**To:** RCS Harmony Partners  
**From:** Michael Huff, Principal Fire Protection Planner  
**Subject:** **Harmony Grove Village South County Club Drive Road Section**  
**Date:** October 19, 2017  
**Attachment(s):** Country Club Drive Bridge Section

Subject: Harmony Grove Village South – Country Club Drive Section

COUNTRY CLUB DRIVE (PUBLIC) - ROADWAY FITS WITHIN EXIST. 50' R/W

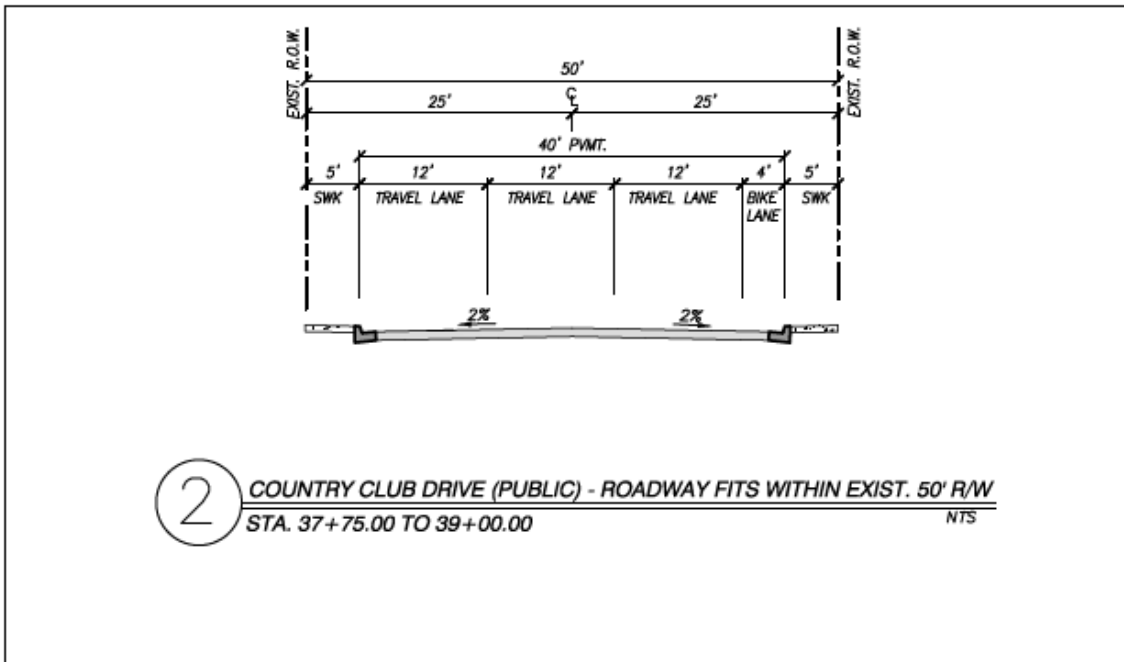
Dudek has reviewed the Harmony Grove Village South Bridge/Road Section prepared by Project Design Consultants and dated 10/13/2017 (attached). The graphic depicts a 50-foot wide right-of-way which includes three travel lanes, bike lanes and sidewalks. The two primary travel lanes are each 12-feet wide. The third travel lane, provided as a measure to increase traffic flow during an emergency, is located between the primary travel lanes and is also a code consistent 12-feet wide. Beyond the travel lanes, there are provisions for a 4-foot wide bike lane and a 5-foot wide pathway on the eastern edge of Country Club Drive and a minimum 5-foot wide trail along the west edge of Country Club Drive. The road, as configured, complies with the San Diego County Consolidated Fire Code and Rancho Santa Fe Fire Protection District Code (Sec. 503.2.1, respectively) for 12-foot wide travel lanes and 24-foot minimum unobstructed road width (two lanes) and 36 feet for three lanes.
